Novel Hurricane Knit Garments Ltd (10162)

Arabi Fashions Ltd (9473)

09.APRIL.2014

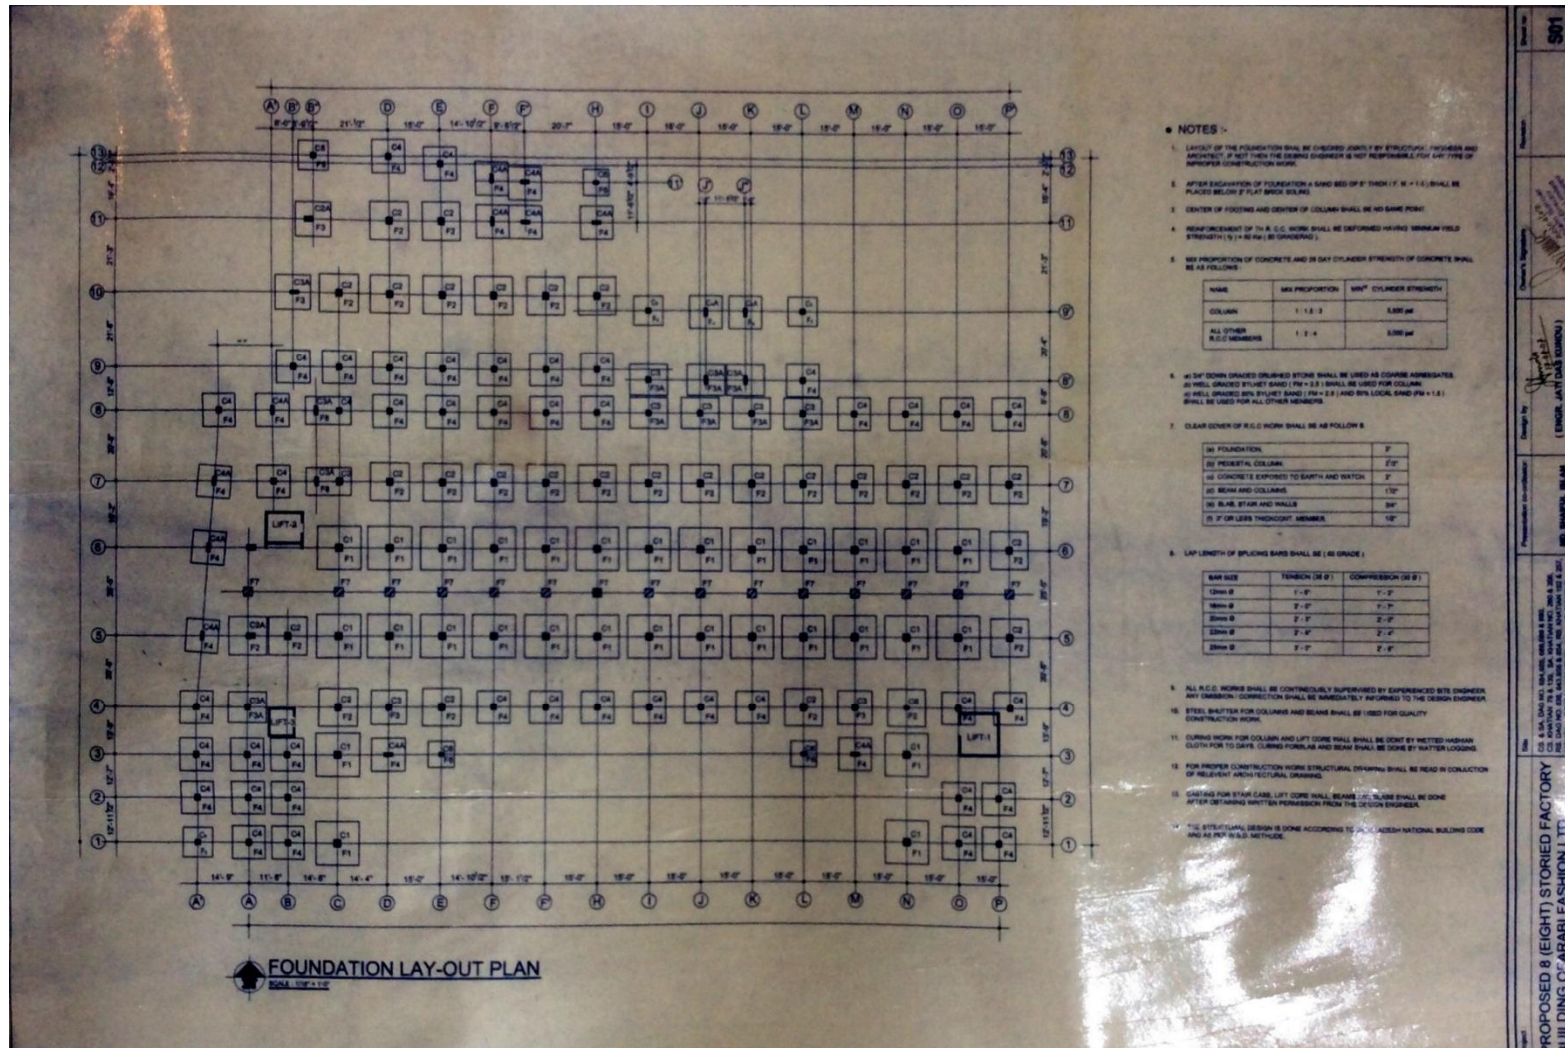
The West elevation steps in and out.
The drawings show this to be a flush
wall.

ITEM 2: West elevation does not quite match drawings

West elevation does not match with drawings

- Conduct engineering assessment to ensure frame is sufficiently robust.
- Update drawings to reflect as built condition.
